Comment Date: January 28, 2012 01:17:57AM  
Supplement to the Draft Solar PEIS  
Comment ID: SEDDSupp20185

The Supplement to the Draft Solar PEIS (SDPEIS) evaluates three alternatives: a No Action alternative; a Modified SEZ Alternative ("Modified SEZ Alternative"); and a Modified Solar Energy Development Program Alternative ("Modified Program Alternative"), selected by BLM as the preferred alternative.

Figure 2. Land Conservation Values: No Action Alternative

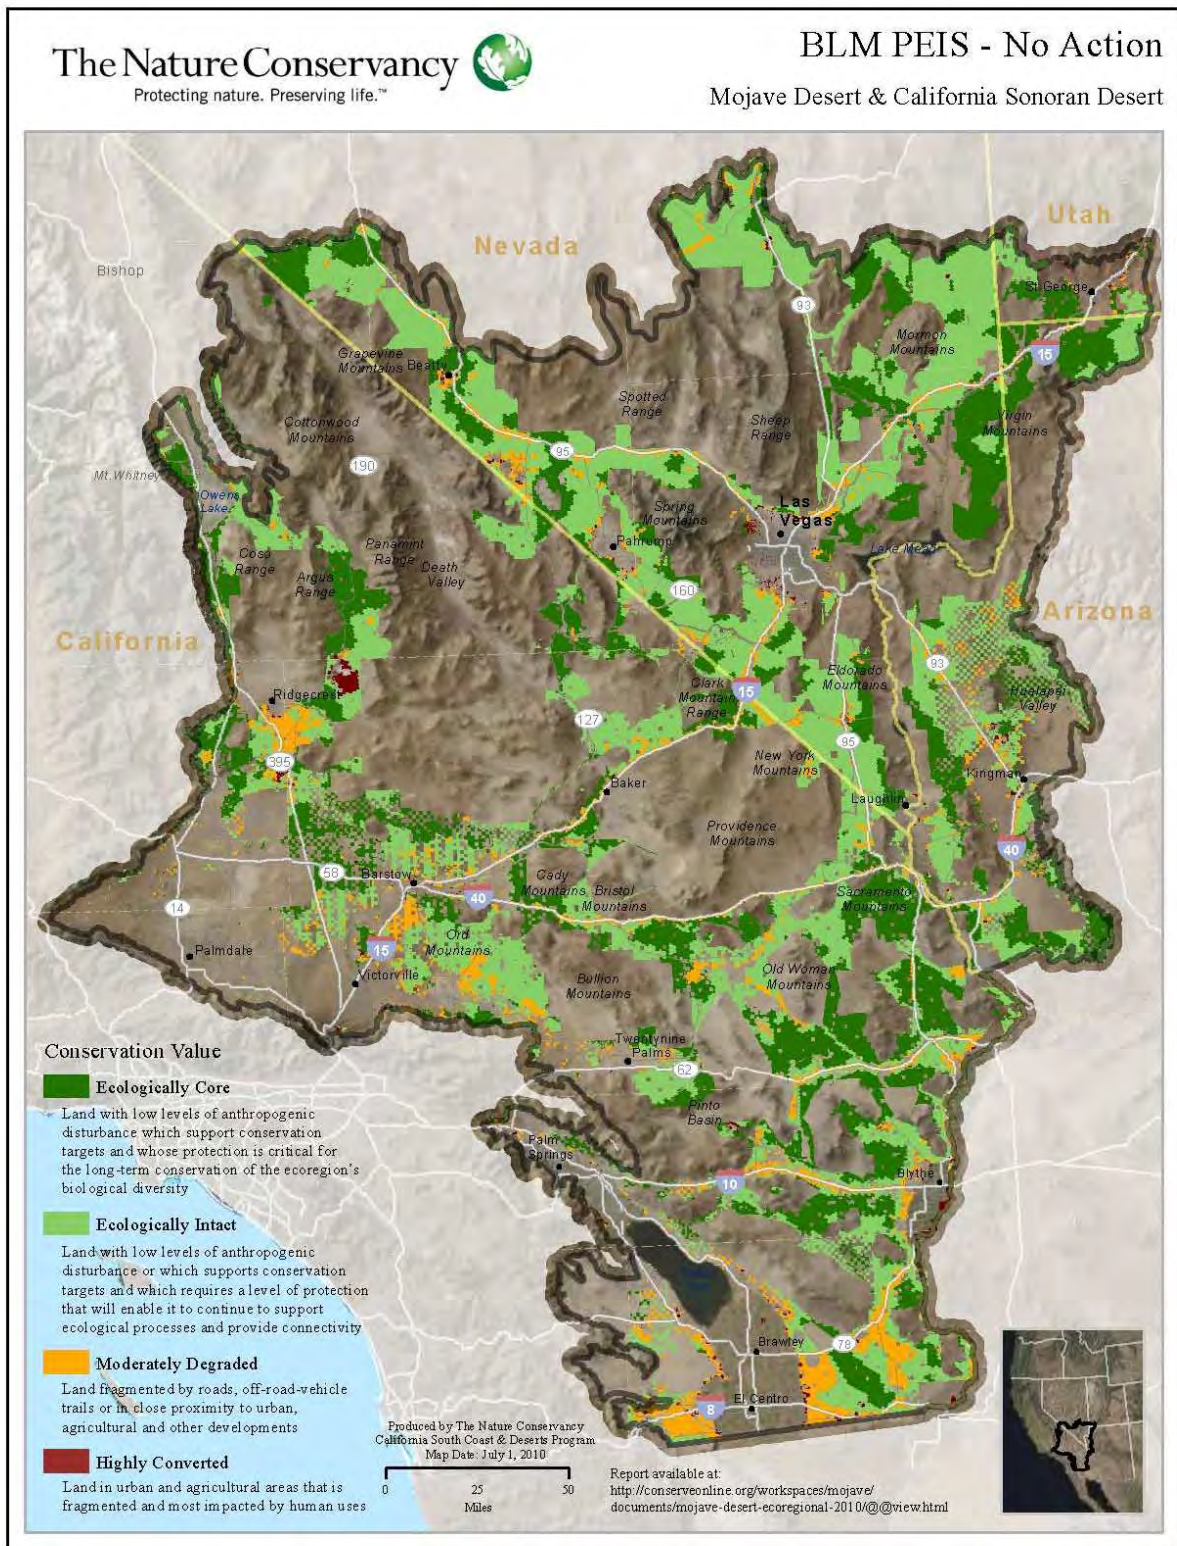
- Figure 2: This map may need to be modified due to different rules for the No Action alternative between the original PEIS and the Supplement to the PEIS. Changes have been made to accommodate updates in GIS data for National Monument boundaries.
- Figure 3: We need to standardize what we call this alternative. Within the Supplement to the PEIS it is called the "Modified Program". The text of this document also calls this alternative the "Modified Program Alternative". The figure should reflect this change.
- Figures 6, 8-11: The title of these figures is "SEZ Initial Assessment". This language is open to revision.

***Figure 6. Amargosa Valley SEZ***

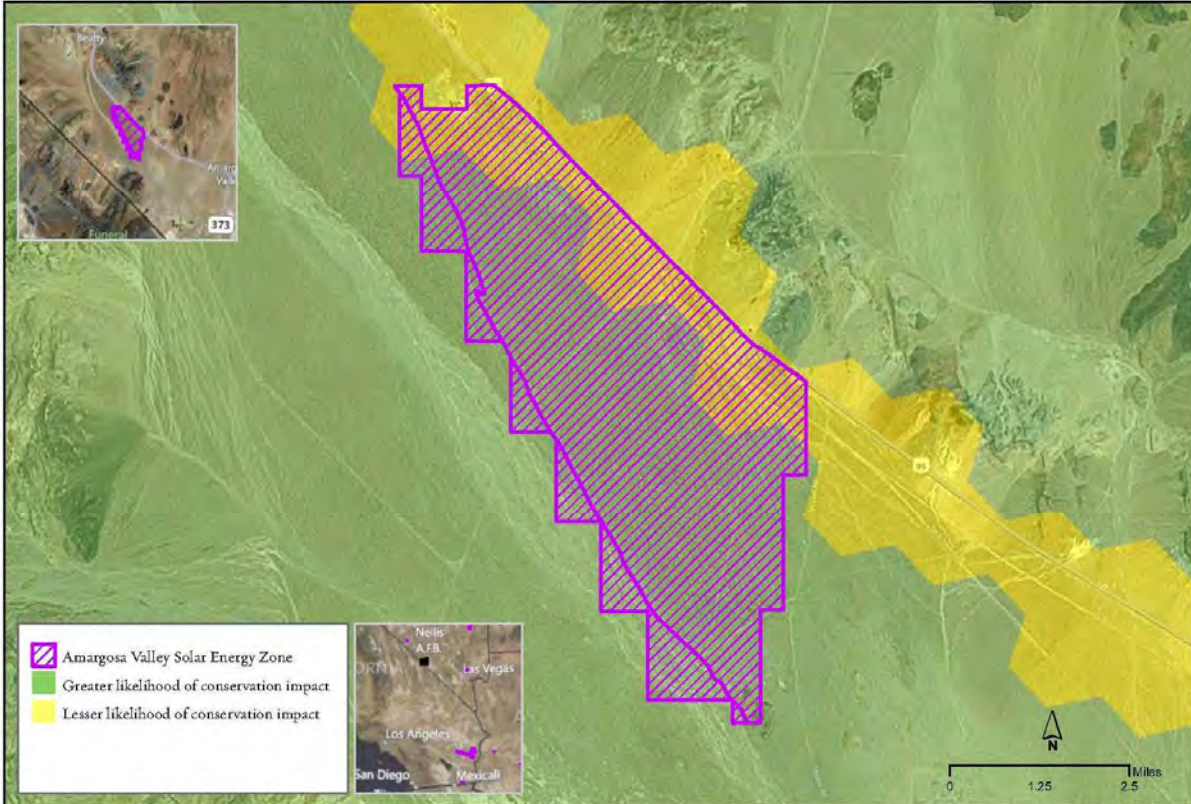
This valley (Figure 6) is already scheduled to be heavily compromised by ongoing existing renewable energy applications, two of which are on the "fast track" course. There has been no explanation why additional facilities are needed in this general area given the scale of the existing proposed facilities. According to the Nature Conservancy's 2010 Ecoregional Assessment for the Mojave Desert, the majority of this SEZ is contained within Ecologically Core zone with an additional 1,278 acres of Ecologically Intact lands. Only one quarter of this SEZ is within Moderately Degraded category, and that principally located along US Highway 95.

If there is a credible argument to be made for any solar development in this area, let alone additional renewable energy to be generated in this vicinity after the build out of several existing "fast track" solar applications, that development should occur only in the moderately degraded corridor paralleling US 95. We strongly urge that this SEZ should be eliminated from further consideration, and, if not, that any approvals be given only after the highest level of scrutiny and subject to carefully considered mitigation requirements, especially those related to water use.

Figure 7. Big Dune in Amargosa Valley with Likely Sand Transport Pathways

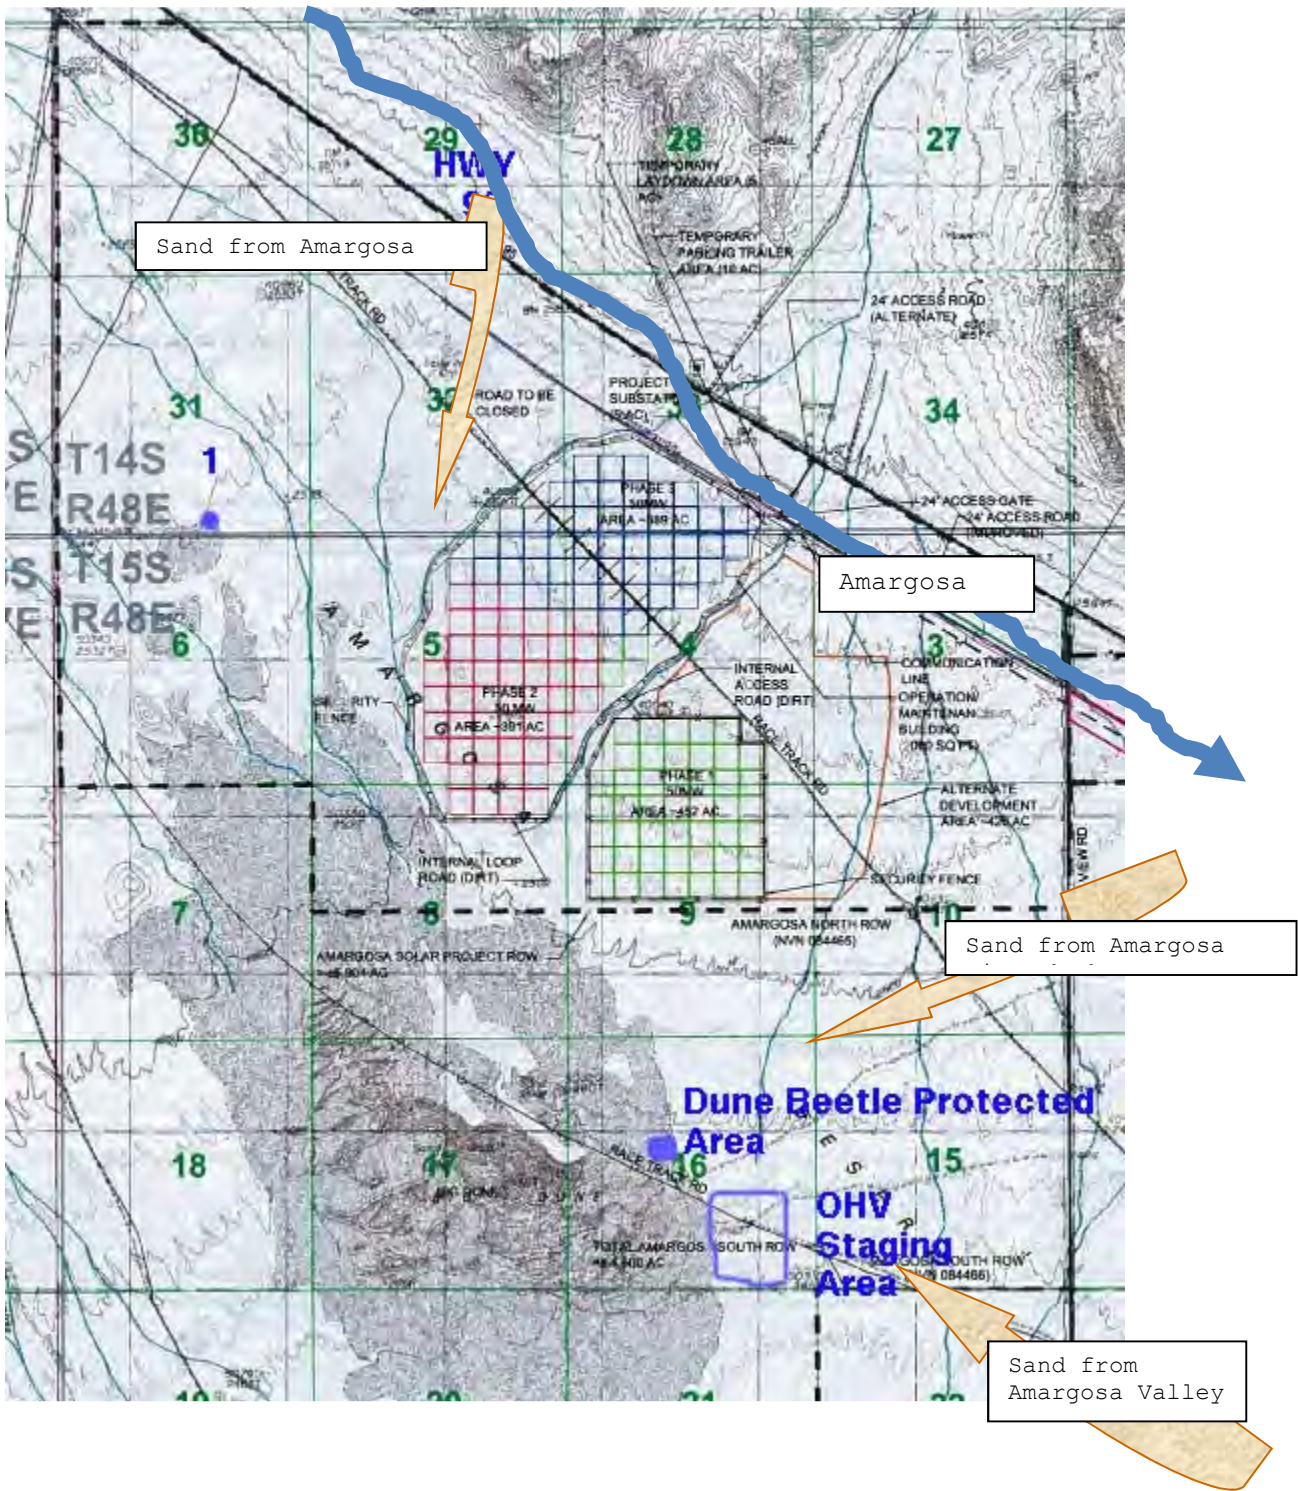
Additionally, the presence of Big Dune at the core of the Amargosa Valley should cause serious concerns that the proliferation of renewable energy facilities will interrupt important sand transport pathways from the Amargosa River bed and nearby dry lake beds to the south and east of this valley (Figure 7).

**Figure 8. Dry Lake SEZ**

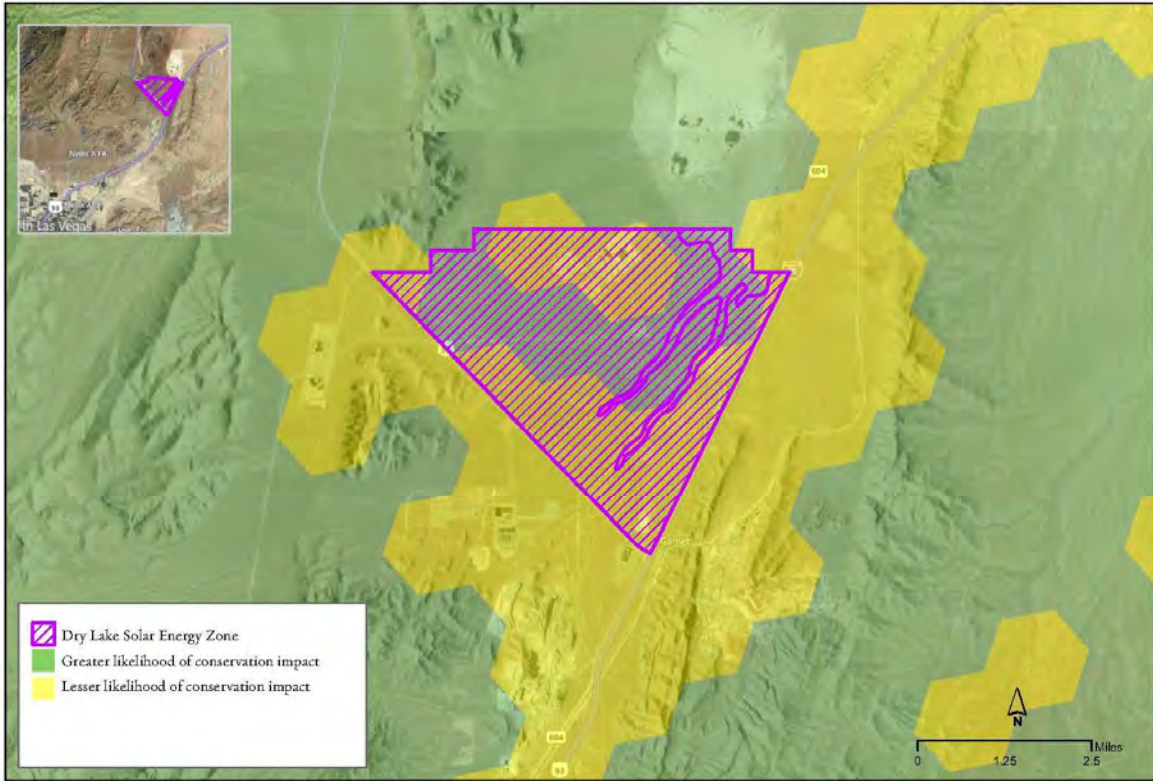
The majority of this proposed SEZ is in ecologically intact acreage. With the exception of important washes that drain into a playa wetland at the northern end, the vegetative communities and species contained within the boundaries of this SEZ are common throughout the Mojave Desert. The SEZ is surrounded by existing renewable energy facility applications that would likely take precedence over any facility to be developed within this SEZ, and as such it is difficult to justify the additional development on washes that are vital to maintaining an ephemeral wetland community. The location is proximate to the likely end user of power generated here (Las Vegas Valley) and is heavily compromised by existing facilities including considerable existing power transmission lines.

This location is generally suitable and appropriate with the exception of the washes leading to the playa wetland at the northern end of the SEZ. This area should be eliminated from the SEZ and the acreage could be replaced with that to the east and south of the Dry Lake on either side of Interstate Highway 15.

***Figure 9. Gold Point SEZ***

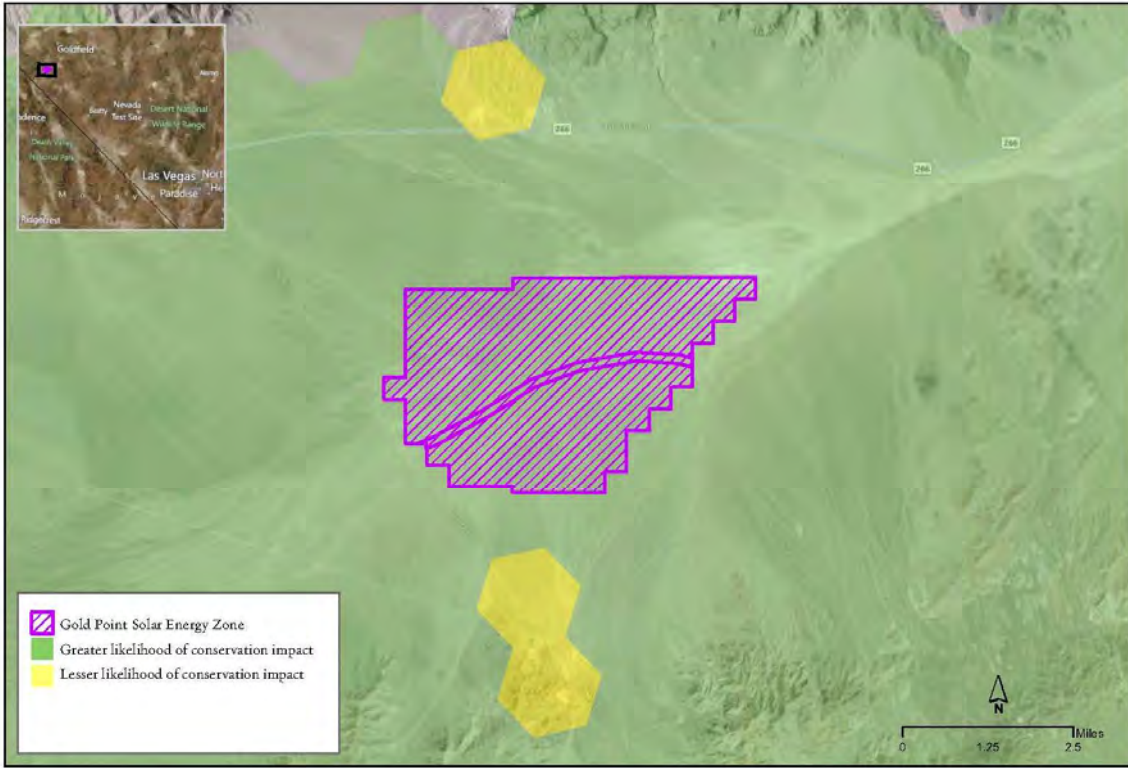
The general vicinity serves as habitat for several locally important species as identified in the PEIS such as Pronghorn antelope and Greater Sage Grouse. The proposed transmission corridor is particularly problematic for both of these species.

This SEZ is remote and not regionally significant as far as demonstrated power needs and furthermore is currently ecologically intact. It should be removed from consideration or relocated to nearby degraded or converted lands. Moving the SEZ could also alleviate transmission corridor concerns since the new corridor could parallel US 95 without appreciable additional impacts to the Pronghorn antelope and Greater Sage Grouse.

*Figure 10. Imperial East SEZ*

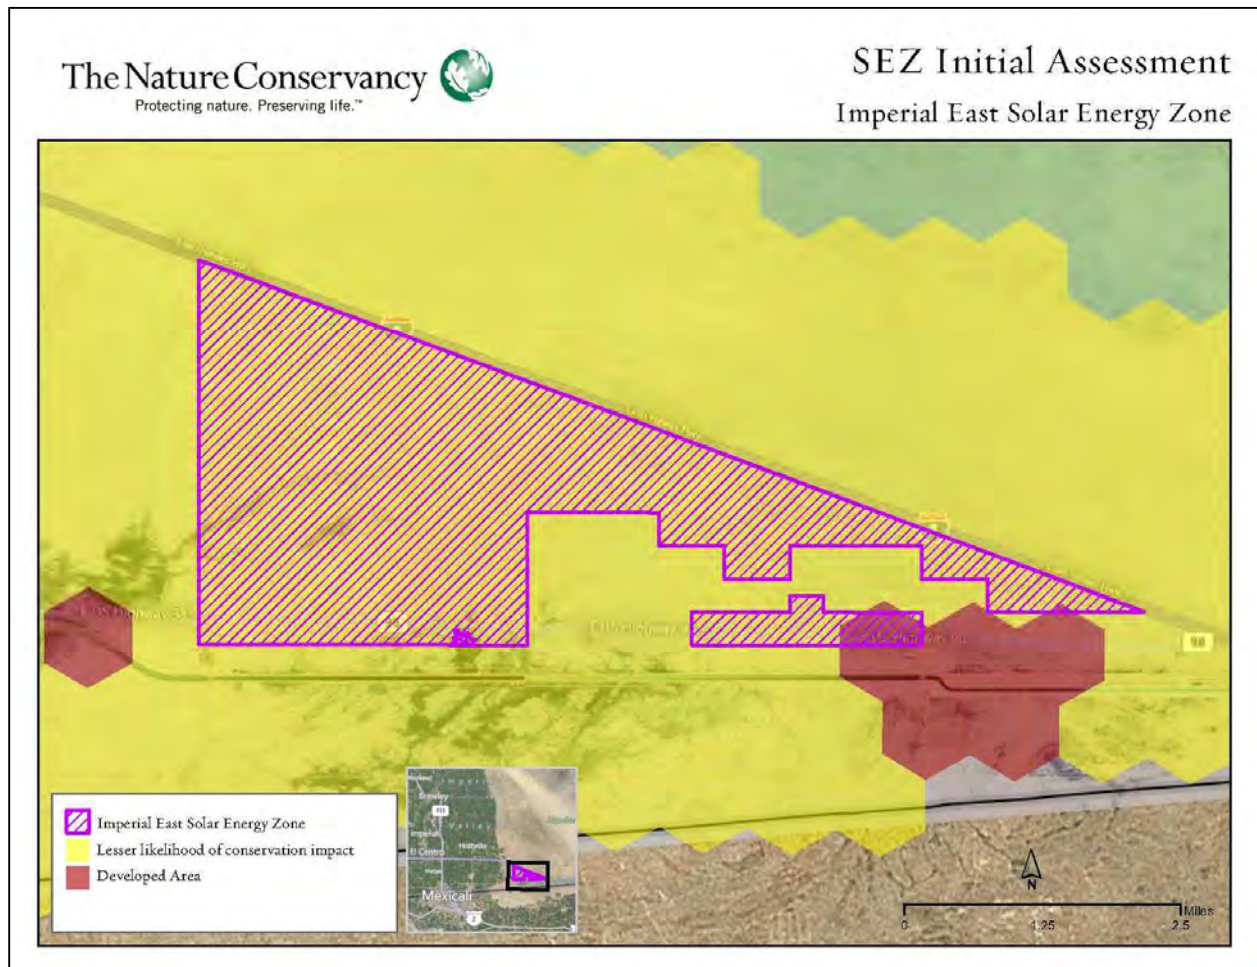
The Imperial East SEZ is comprised entirely of lands that have been designated as having lower conservation value by the 2009 Framework for Effective Conservation Management of the Sonoran Desert in California. Despite this designation, in-depth local surveys are required to determine if developments proposed within this area would have significant impacts on conservation targets or ecological processes. Even lands that have relatively low conservation value may harbor important biodiversity elements.

*Figure 11. Riverside East SEZ*

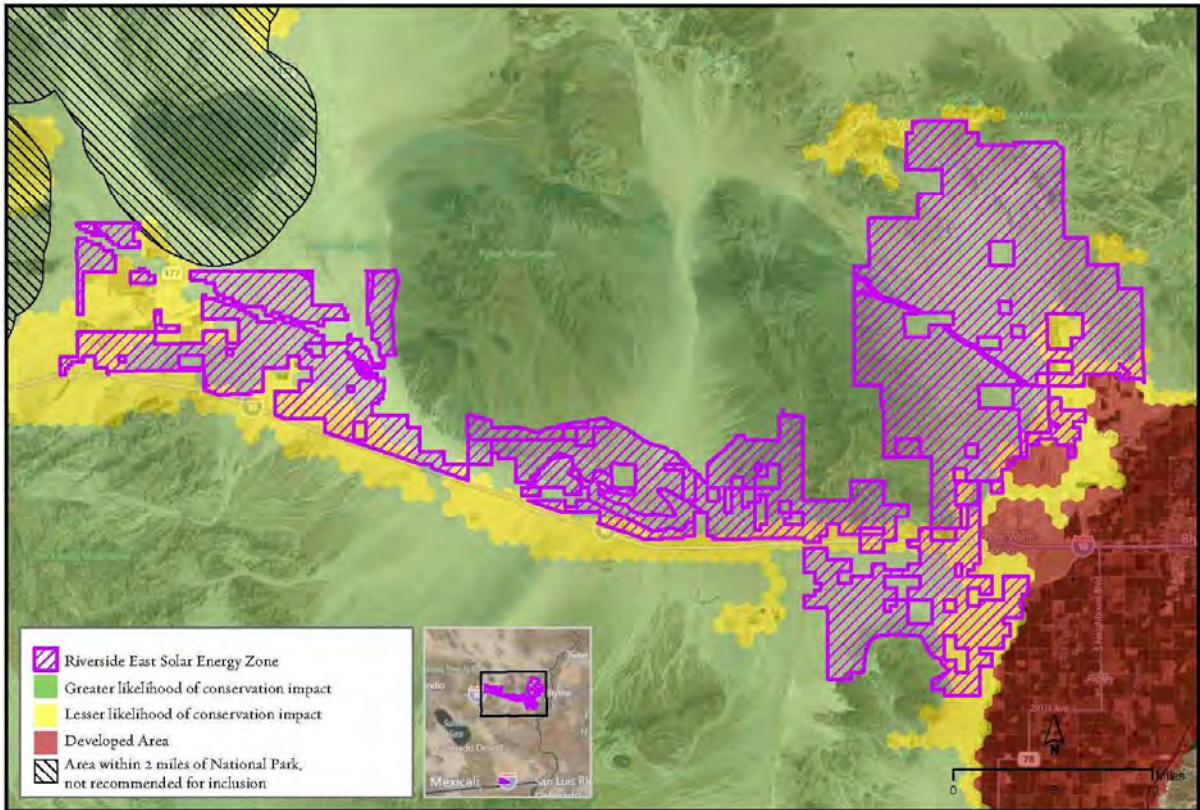
The Riverside East SEZ is divided between Moderately Degraded, Ecologically Intact and Ecologically Core lands. Over 31% of the Riverside East SEZ is comprised of lands identified as having high conservation value in the 2009 Framework for Effective Conservation Management of the Sonoran Desert in California because they are un-fragmented and host important species and communities. We recommend the withdrawal from this SEZ of the highest conservation value lands shown on the accompanying map. Areas that should be withdrawn from this SEZ include lands around Palen Dry Lake in the northwestern portion of the SEZ, and the high value habitat northwest of Blythe. In addition, the large size and long, thin shape of this SEZ may hinder the north-south movement of Bighorn Sheep and other wide-ranging terrestrial vertebrate species. The shape of the SEZ should be modified to incorporate viable wildlife linkages and provide connectivity for hydrological and ecological processes such as sand movement in this region.
